ROCKY FLATS SITE REGULATORY CONTACT RECORD

Purpose: Soil Disturbance Review Plan (SDRP) for Regrading the East Perimeter Channel (EPC) and Associated Diversion Berms at the Original Landfill (OLF)

Contact Record Approval Date: November 22, 2013

Figure 1. OLF Soil Disturbance, Filling and Grading Location

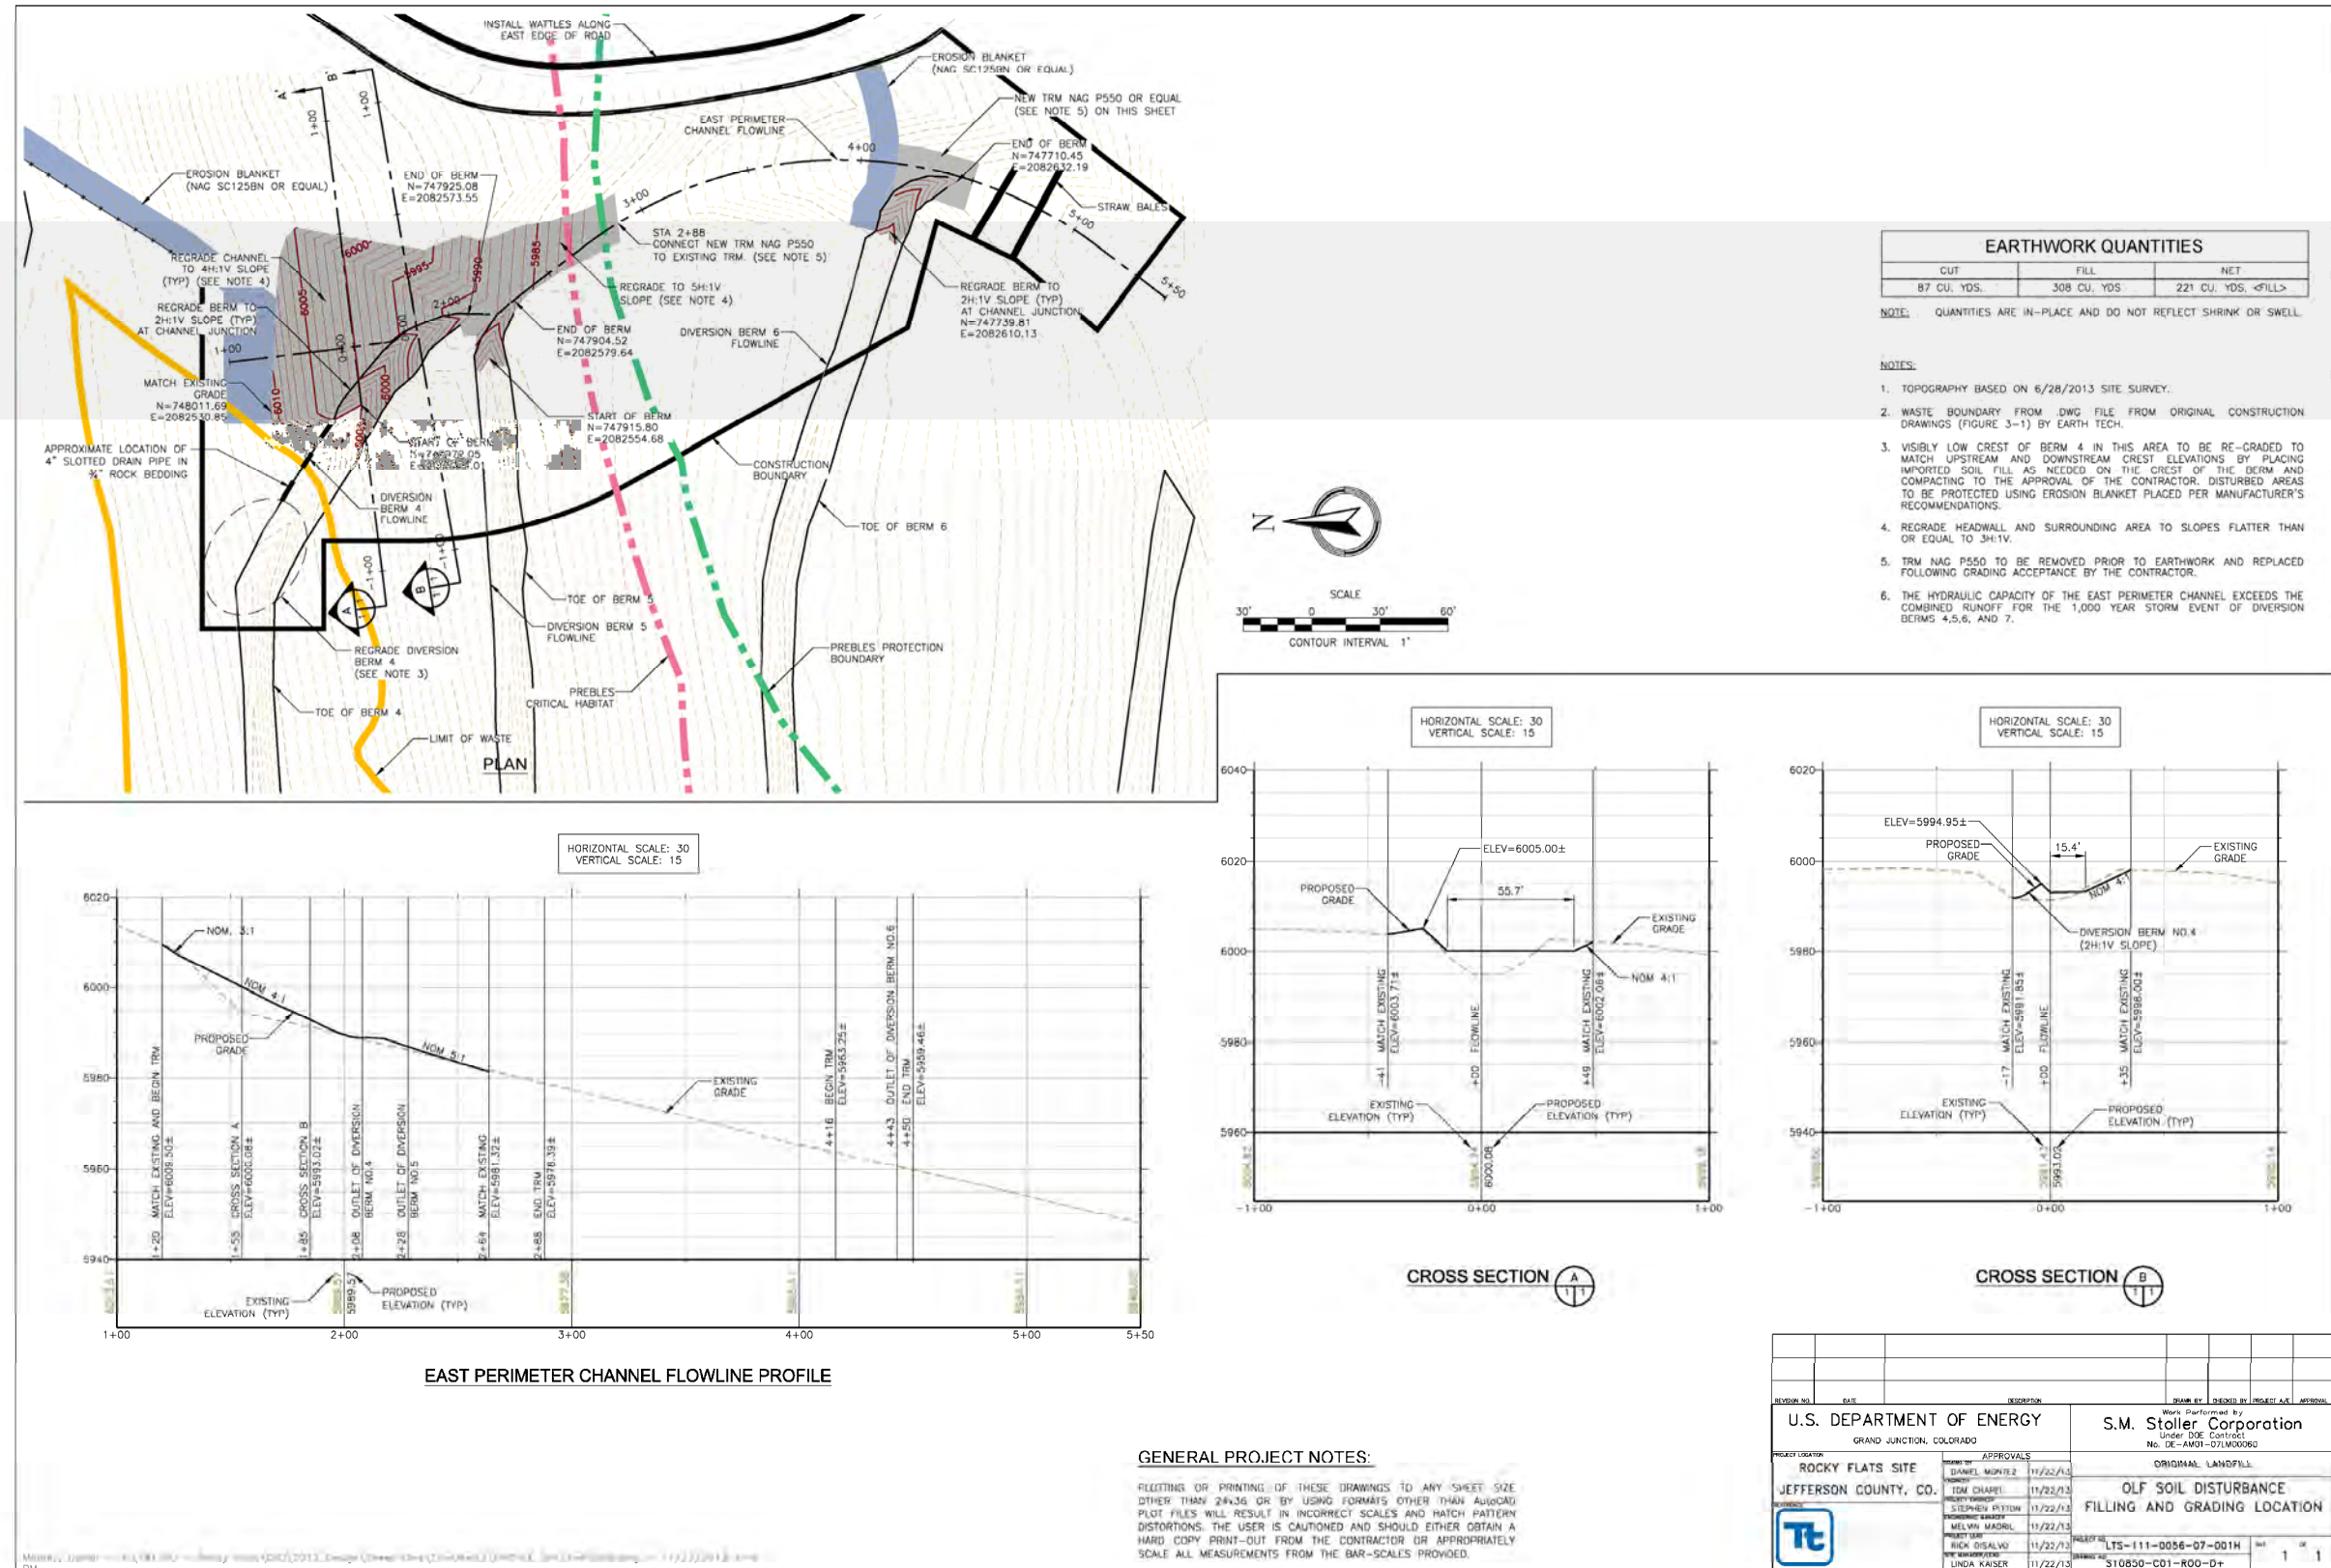
Discussion: DOE and CDPHE met on November 19, 2013, to review DOE's proposed grading plan which results primarily in raising the EPC elevations but some areas will have slightly lower elevations. Figure 1 shows the location and anticipated aerial extent of the soil disturbance. A slotted drain pipe bedded in crushed rock was installed in the eastern end of diversion berm 4 as part of the initial response to the localized distress (see CR 2013-02) and this will be left in place.

Contact Record 2013-03 Figure 1 shows the location and the lateral and vertical extent of the excavation and soil disturbance. The material (Rocky Flats Alluvium) (RFA) excavated from the cut areas will be used as fill in the fill areas. Additional clean RFA fill will be needed to complete the regrading. The additional clean RFA fill material will come from the Bestway, Inc. commercial gravel pit located directly west of the Central Operable Unit.

Resolution: CDPHE has reviewed information regarding the proposed soil disturbance and excavation and, after consultation with EPA, has approved the proposed activity and the proposed grading plan. CDPHE has determined that the proposed activity will not compromise or impair the function of the remedy or result in an unacceptable release or exposure to residual subsurface contamination. CDPHE has also determined that the proposed project meets the rationale and objectives of ICs 3 and 6.

Figure 1. OLF Soil Disturbance, Filling, and Grading Location

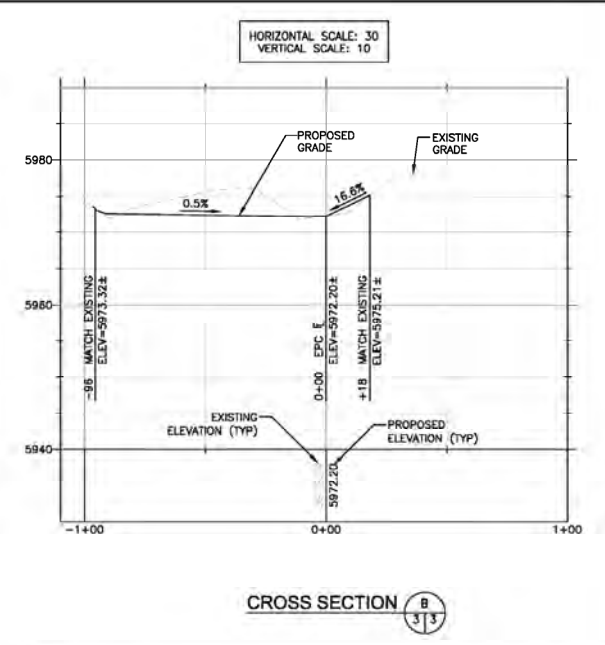
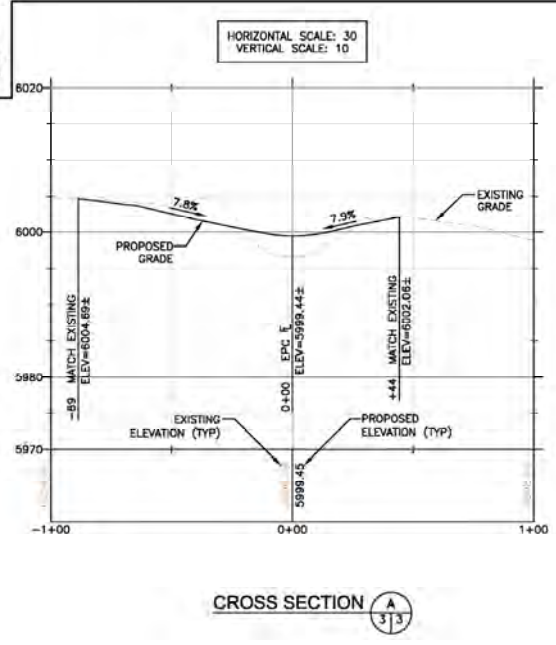
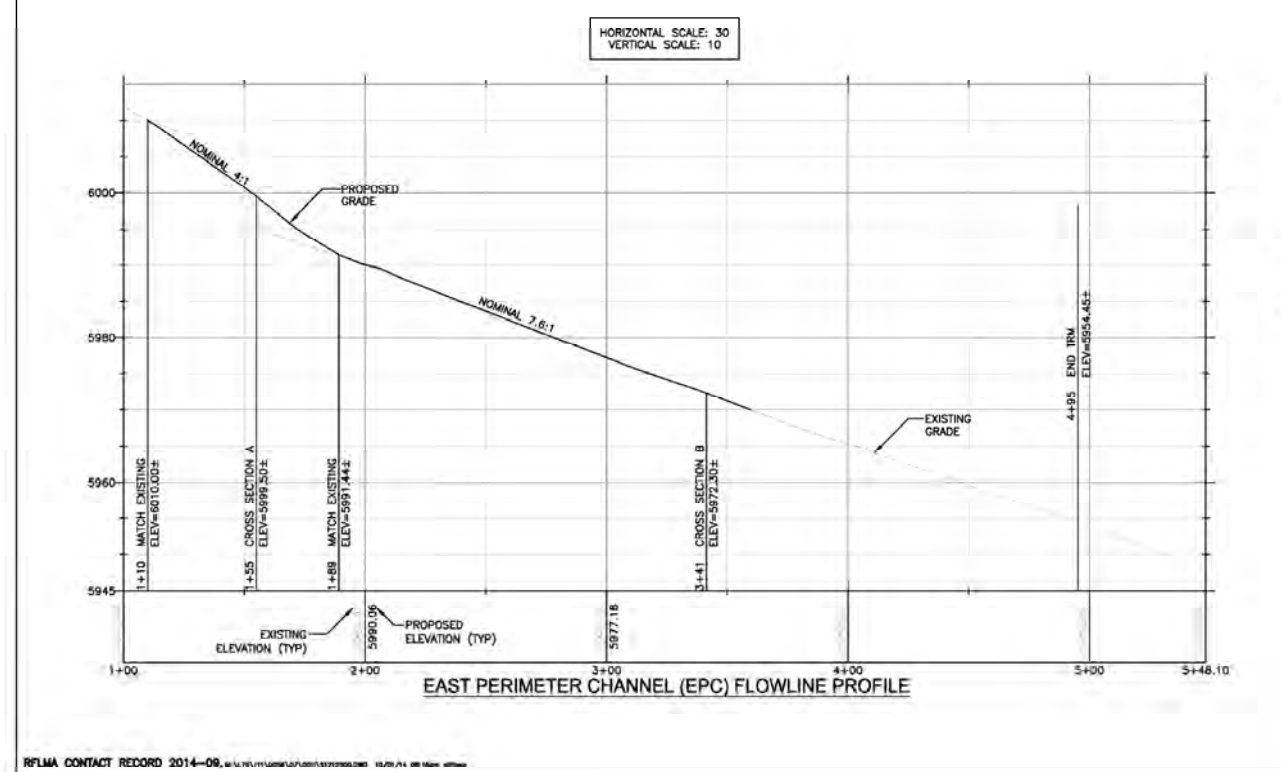
Discussion: DOE, CDPHE, and EPA met on August 5, 2014, to review the proposed update to the grading plan. The primary updates to the December 2013 grading plan are to cut back the ends of berms 4, 5, and 6 and taper the sides of the channel back to a more gradual slope. Figure 1 shows the location and anticipated aerial extent of the soil disturbance. The construction boundary is similar to the previous (December 2013) design, but soil disturbance is more extensive. There is a smaller area around the berm 4 flow line inside the “limit of waste” that will have new turf reinforcement material installed for erosion control. In October 2013 a slotted drainage pipe bedded in ¾-inch crushed drain rock was installed in the eastern end of diversion berm 4 as part of the initial response to the localized distress (see CR 2013-02), and this will be left in place. Another 4-inch slotted drainage pipe bedded in crushed drain rock will be installed between berm 5 and 6 to drain water from Seep #2/3 into the EPC. The excess soil will be distributed inside the COU as shown in Figure 2. No intrusive work will be performed within the waste footprint boundary.

Contact Record 2014-09 Figure 1 shows the location and the lateral and vertical extent of the excavation and soil disturbance. The slopes of the western side of the EPC between berms 5 and 6 will not be restored to the existing grade, therefore reducing or removing the 2-foot soil cover; however, this area is outside the "limit of waste." The soil disturbance, regrading, and drainage feature installation work will not change the 2-foot-thick soil cover within the limits of the buried wastes. The material (Rocky Flats Alluvium) excavated from the cut areas will be used as fill in the fill areas. The excess soil will be distributed at designated locations in the COU as shown in Contact Record 2014-09 Figure 2.

Resolution: CDPHE has review information regarding the proposed soil disturbance and excavation and, after consulting with EPA, has approved the proposed activity and the proposed grading plan. CDPHE has determined that the proposed activity will not compromise or impair

Figure 1. Location of Excavation for Storage Shed PV Upgrades Project

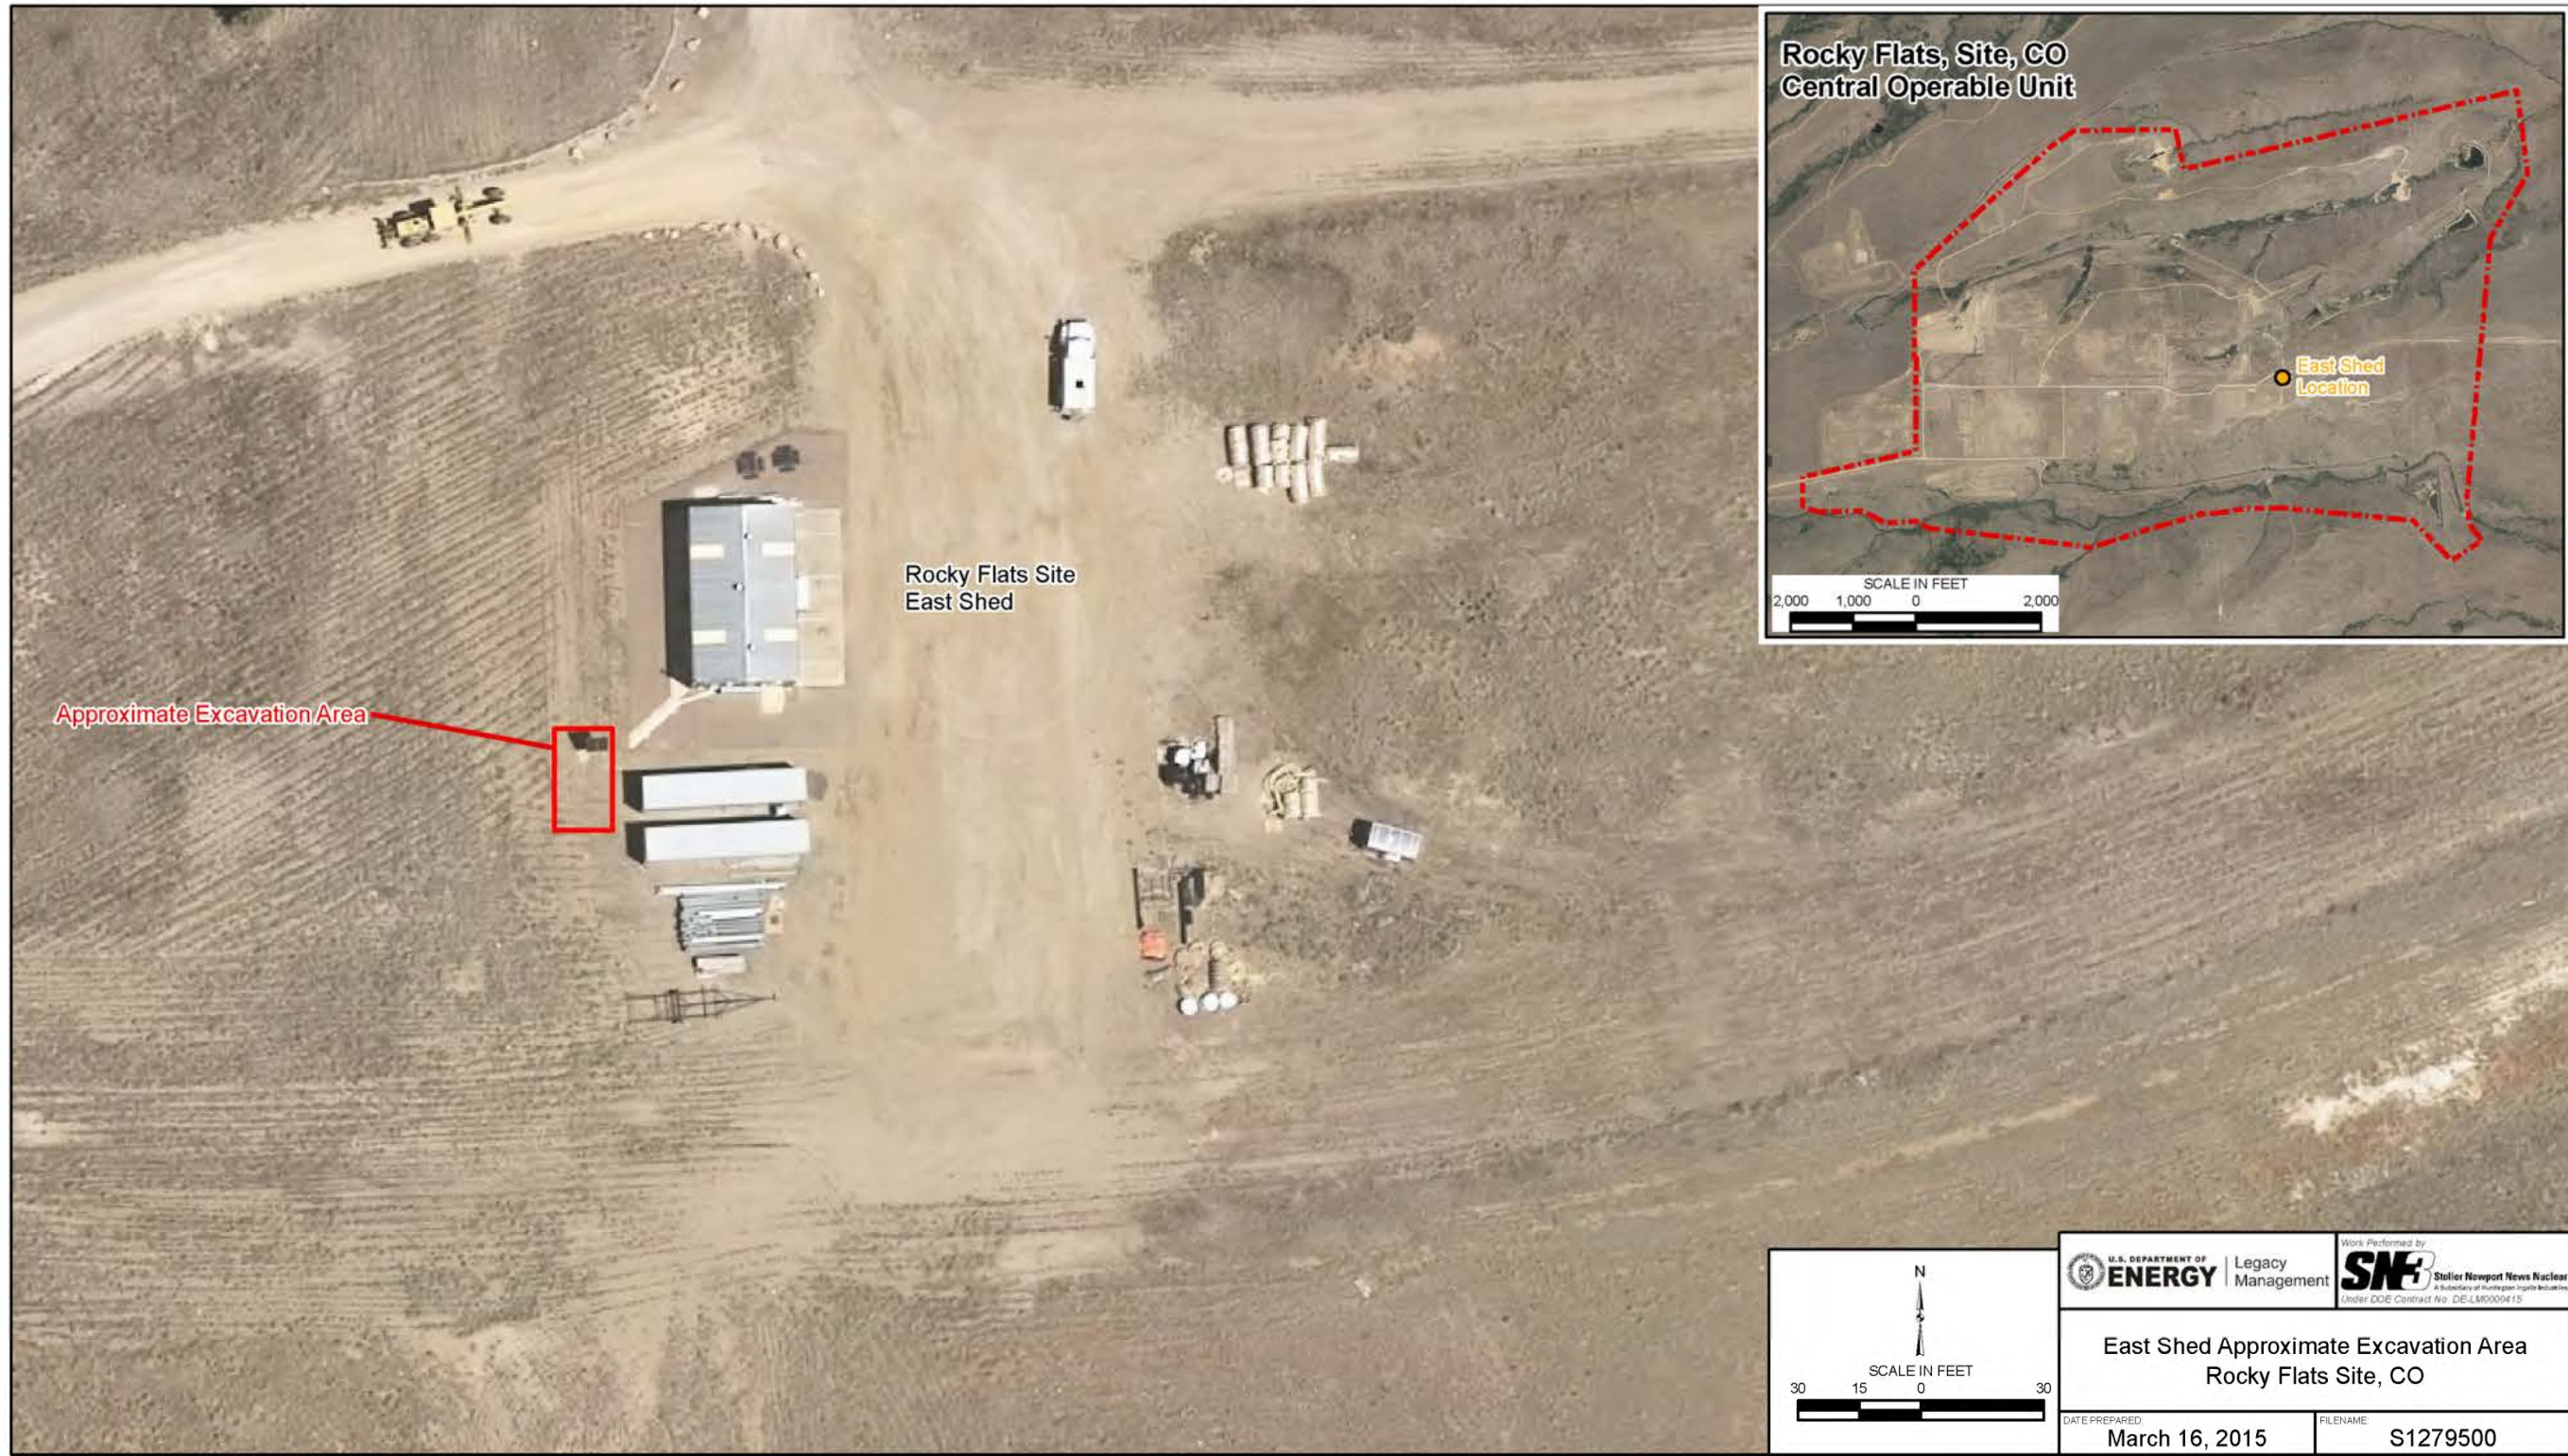
Discussion: The storage shed photovoltaic upgrade project is designed to provide sufficient additional power at the shed to power the existing overhead garage doors, the existing LED lighting, and additional powered hand tools. The existing system shall be evaluated for reusing as much of the existing equipment as possible. The required new PV panels will rest on supports, including the one existing support. The new supports will require 12-inch diameter holes drilled approximately 3 feet deep. The holes will be filled with concrete. The supports will be in an 8-foot by 16-foot (approximate) array with the existing support on the east side of the array.

Holes, 12-inches in diameter and approximately 3 feet deep, will be drilled and filled with concrete. The additional PV panels will be supported by the new concrete footings. Figure 1 in Contact Record 2015-02 shows the approximate location of the new supports.
